**Town of Gorham
 Planning Board Meeting
 July 11, 2022**

Consent Agenda B – Site Plan Review - Leaf Labs LLC – Marijuana Grow and Distribution Facility – a request for site plan review of a 40, 900 sq. ft. industrial building with associated infrastructure on 65 Olde Canal Way. Zoned OCI, Map 34, Lot 3-3. The applicant is represented by Craig Burgess, P.E., of Sebago Technics, Inc.

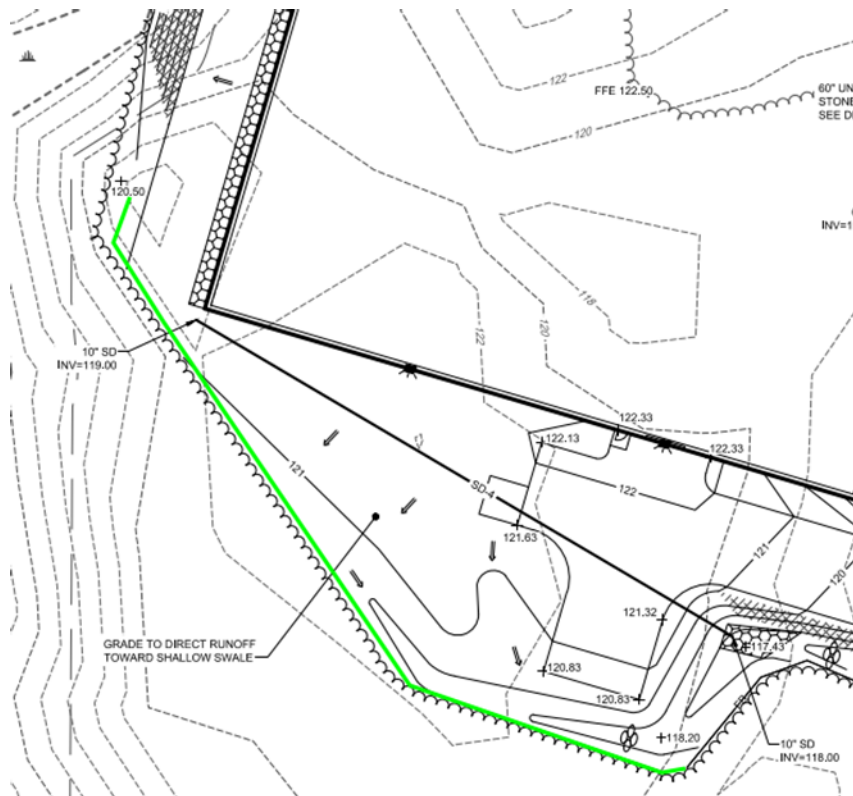
1. Environmental
 - a. Filter berm is proposed as a perimeter erosion control. The southerly filter berm should be extended to tie into the westerly mound for additional erosion and sedimentation

protection. Soil disturbances for grading of the shallow swale and trenching for storm drain (SD-4) would likely result in sediment transport off-site as currently proposed. See sketch of approximate location with the extension shown in green.
